SERVICE BULLETIN

No. 590

Piper Aircraft Corporation

Subject: Inspection of Stabilator Tab Horn/Stabilator Trim Control Rod Attachment

SECTION A-A

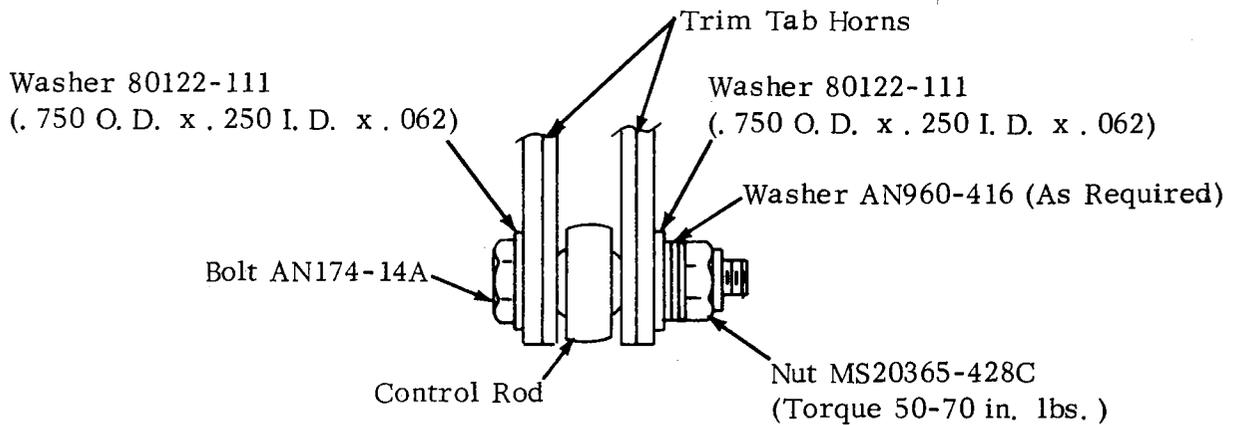
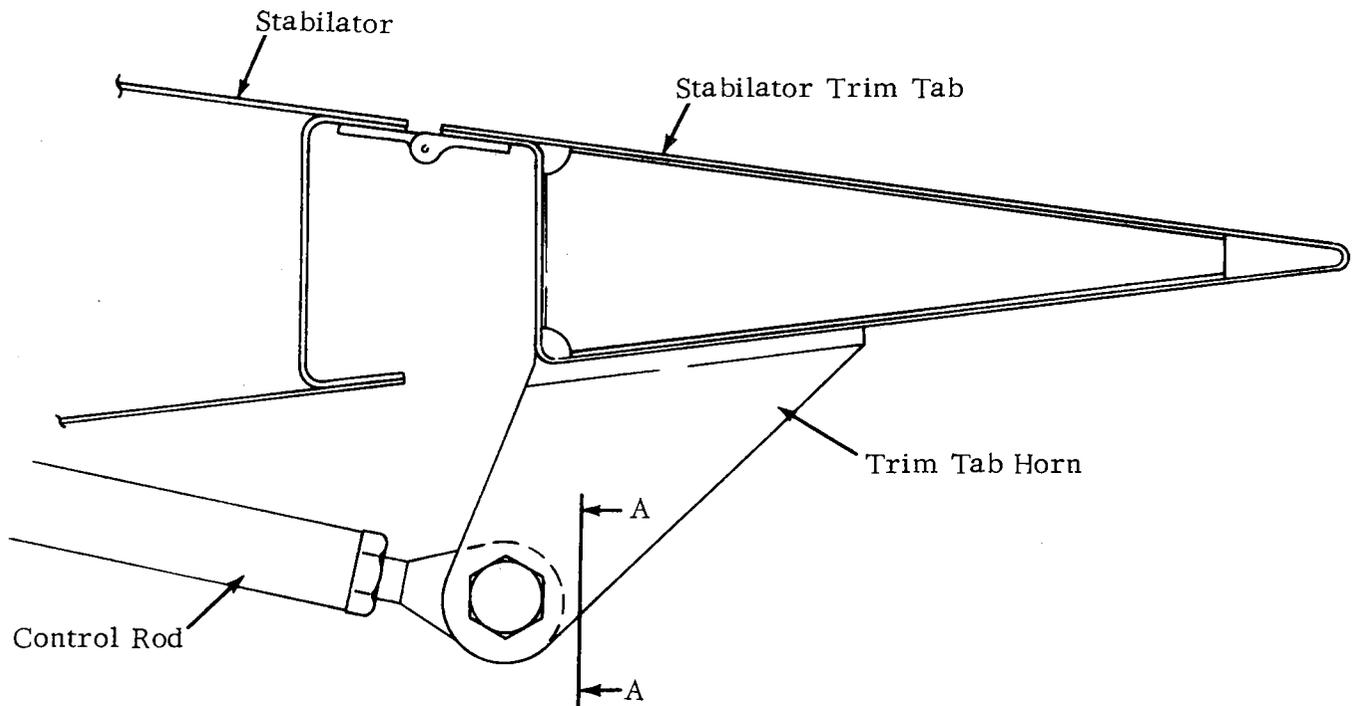
Purpose: It has been brought to our attention that the stabilator tab horn to stabilator trim control rod attachment hardware on the above referenced aircraft may have been improperly assembled and/or torqued. If not corrected, excessive control rod end play and bolt wear and eventual stabilator trim tab vibration may result.

1. Remove AN174-14A bolt from trim tab horn and control rod.
2. Inspect for evidence of nut having cut additional threads on bolt.
3. If evidence of additional threads is apparent, discard bolt and replace with new bolt.
4. Install hardware as shown above.
 NOTE: With 50-70 in. lbs. Torque, the trim tab horns must be tight against the ball of the rod end bearing, the bolt should not turn readily, the nut must not "bottom" on bolt threads and there may be no "end play" in the attachment bolt.
5. Make appropriate Logbook entry of Service Bulletin compliance.
